MFN 06-262
Supplement 4

Subject: **Modified Reactor Building/Fuel Building Truncated Model,
SER-ESB-038 Rev. 5**

**Shimizu Engineering Report SER-ESB-038, Rev. 5,
“Modified RBFB Truncated FE Model Analysis Data,”**

Project	General Electric Company ESBWR Project	Shimizu Document No.	SER-ESB-038
Title	Modified RBFB Truncated FE Model Analysis Data	Rev.	5
		Issued Date	9/22/06
		Revised Date	1/9/07

Figure C-37 Element Forces Comparison NASTRAN to ANSYS (Basemat Section C-C: Axial Force [MN/m])

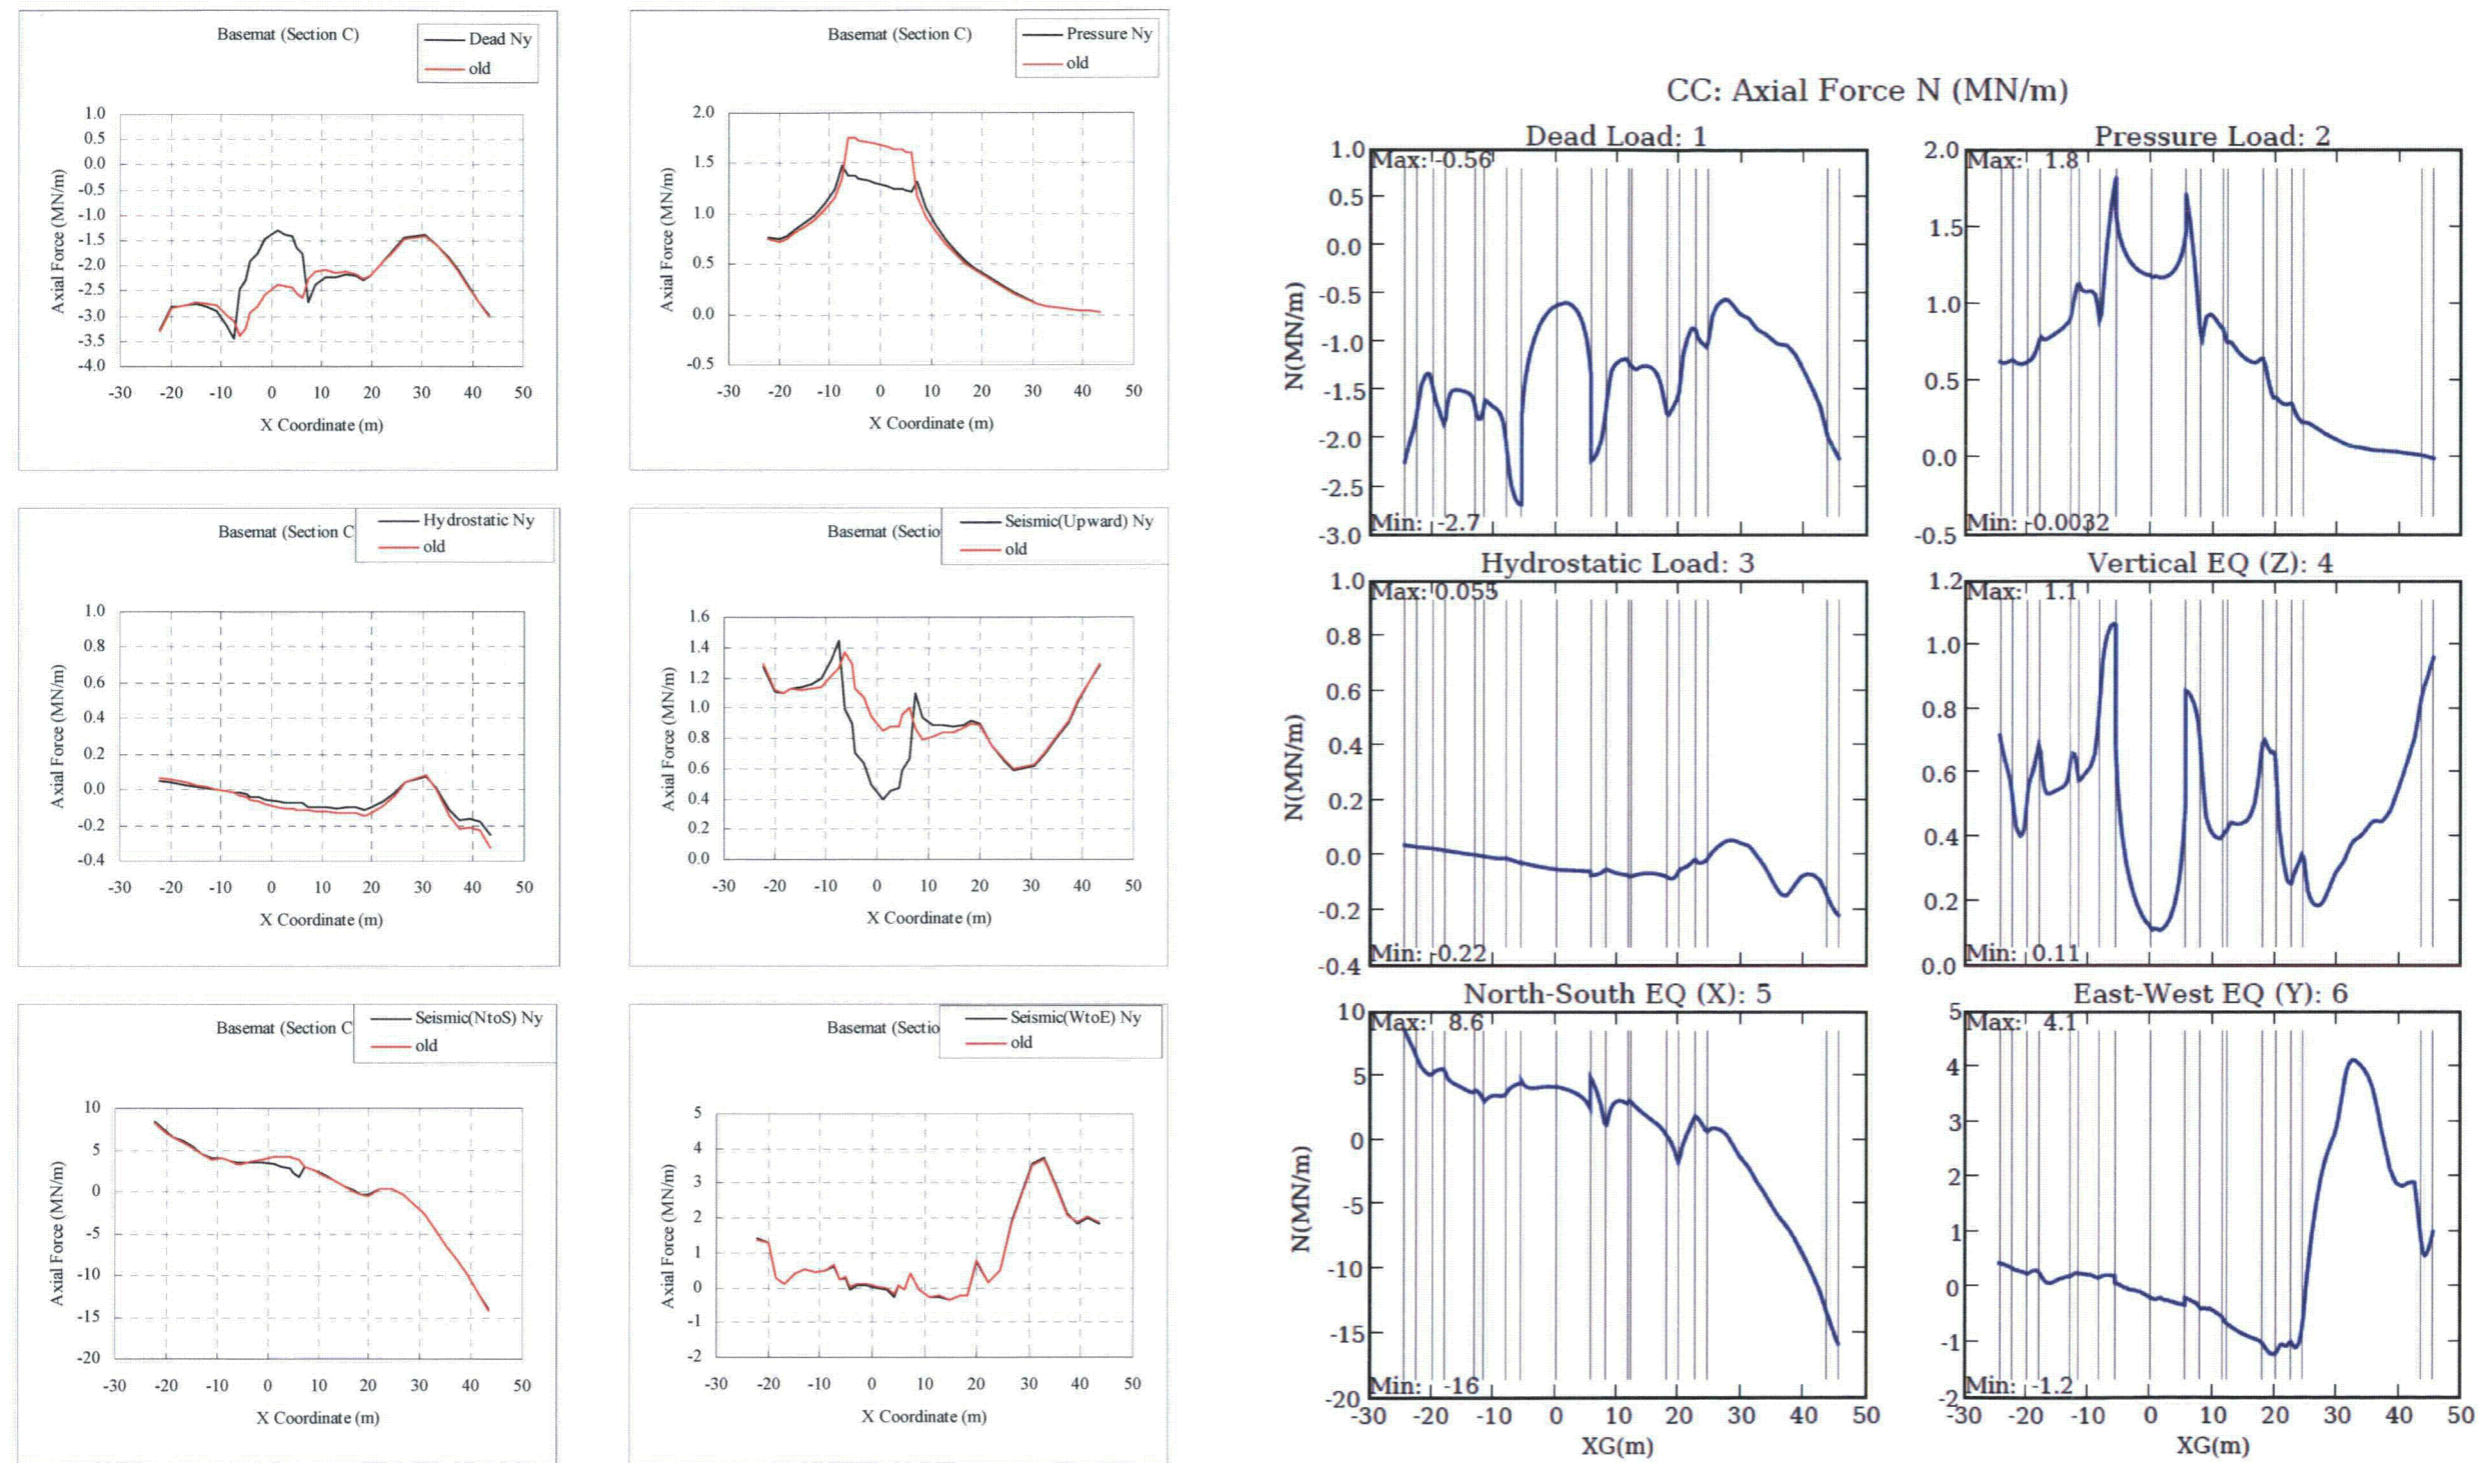
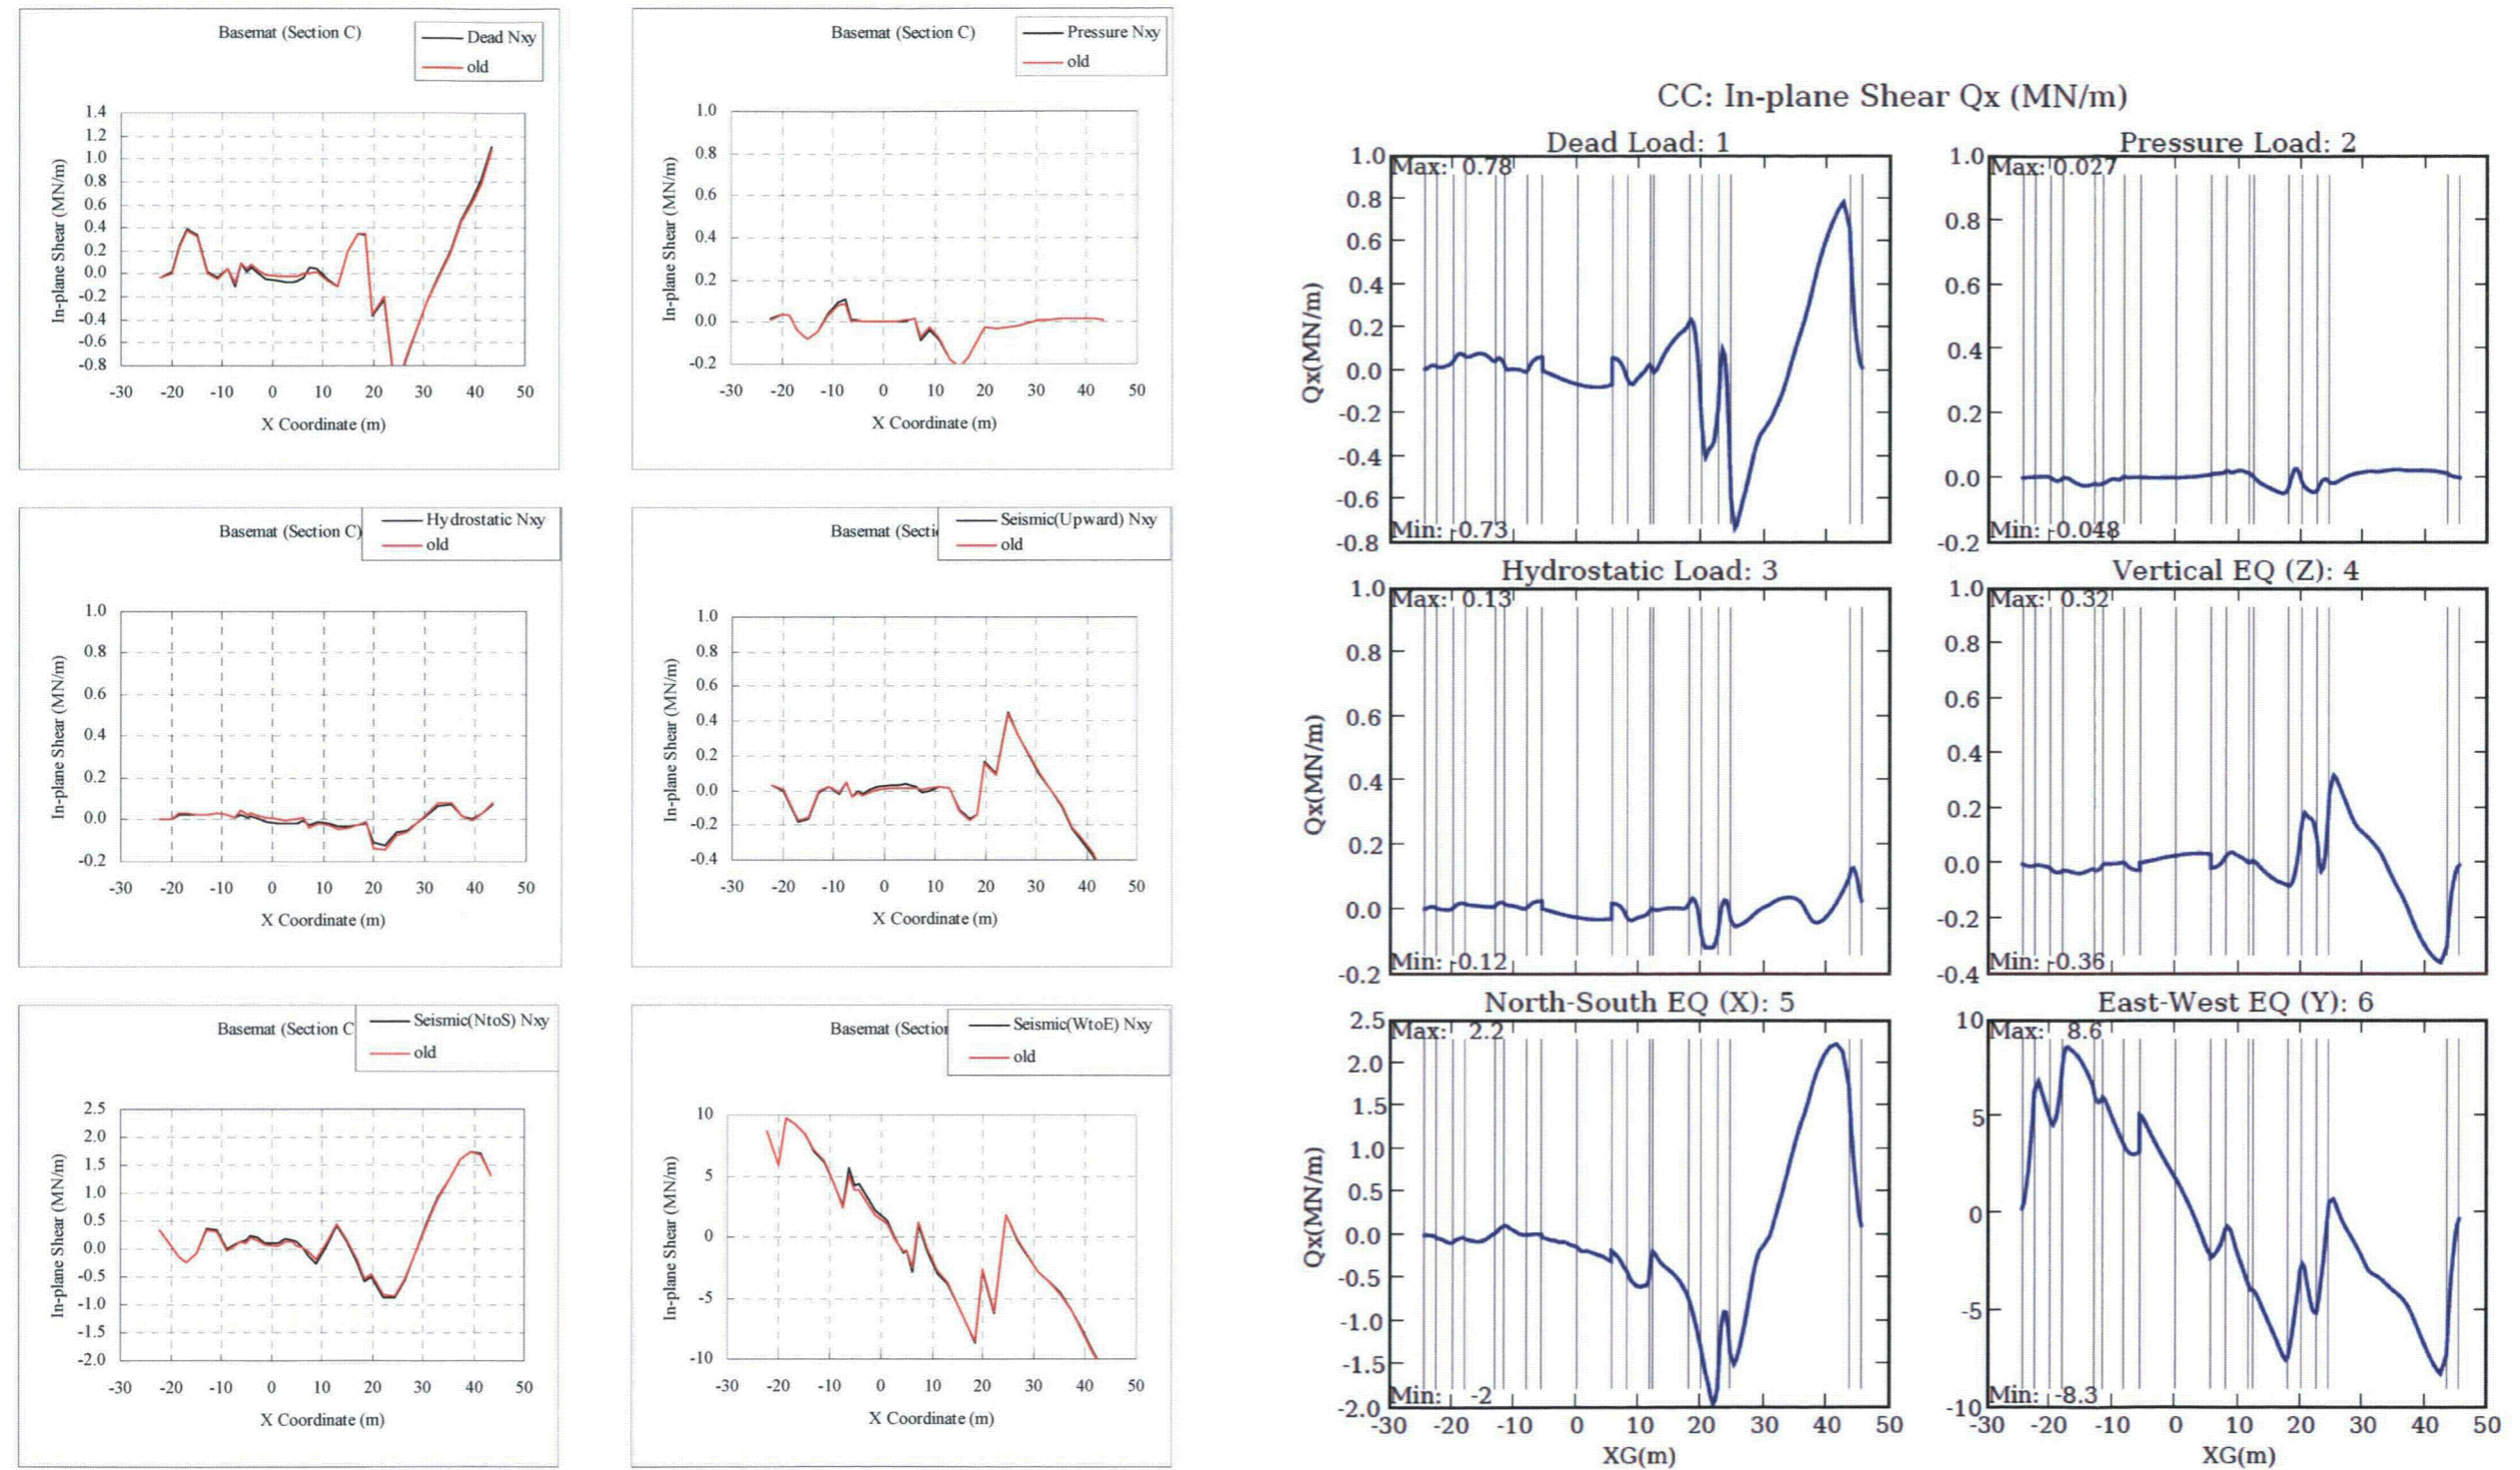
- iii) *The differences of magnitude of forces appeared on basemat inside pedestal:* The result of re-analysis using the updated model shows better agreement. In case of seismic load the magnitude of forces has to be re-compared because BNL's soil spring may not be adequate as pointed out above 3).

- iv) *The differences of magnitude of forces appeared on outer wall of Fuel Storage Pool (FSP):* For the out-of-plane shear forces and moments on RA and F3 wall located around FSP in case of Hydrostatic load, BNL's results are lower than those of GE. GE assumes the some part of differences comes from the difference of estimation levels between both models as pointed out above 8). In order to have a better understanding of the differences, GE would like to request BNL to confirm the input data for Hydrostatic load.
